**ERRATA SHEET FOR  
ANSI/ASHRAE/IES STANDARD 90.1-2019 (I-P Edition)  
Energy Standard for Buildings Except Low-Rise Residential Buildings**

**May 20, 2021**

The corrections listed in this errata sheet apply to ANSI/ASHRAE/IES Standard 90.1-2019, I-P Edition. The first printing is identified on the outside back cover of the standard as “Product code: 86270 10/19”, the second printing as “Product code: 86270 2/20 Includes errata dated March 18, 2020. Shaded items have been added since the previously published errata sheet dated April 8, 2021 was distributed.

Figure 3.2-5 Computing the secondary sidelighted area.

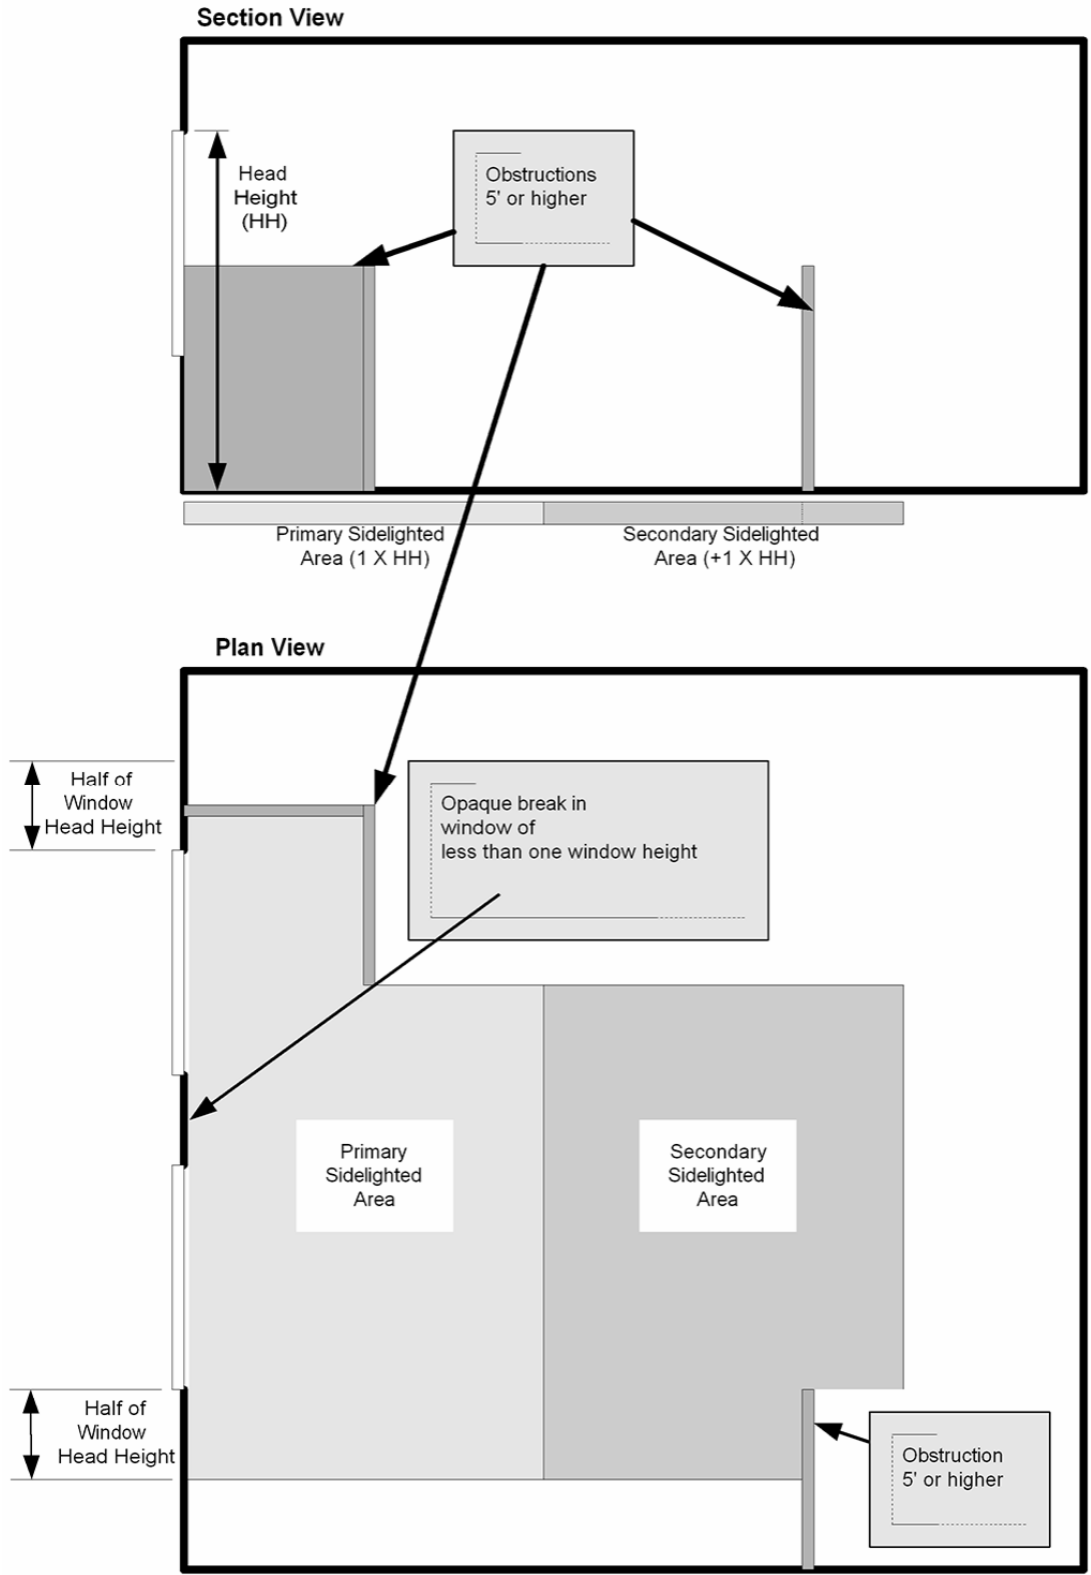
- 18**            **Figure 3.2-5 Computing the secondary sidelighting area.** Replace Figure 3.2-5 with the attached.
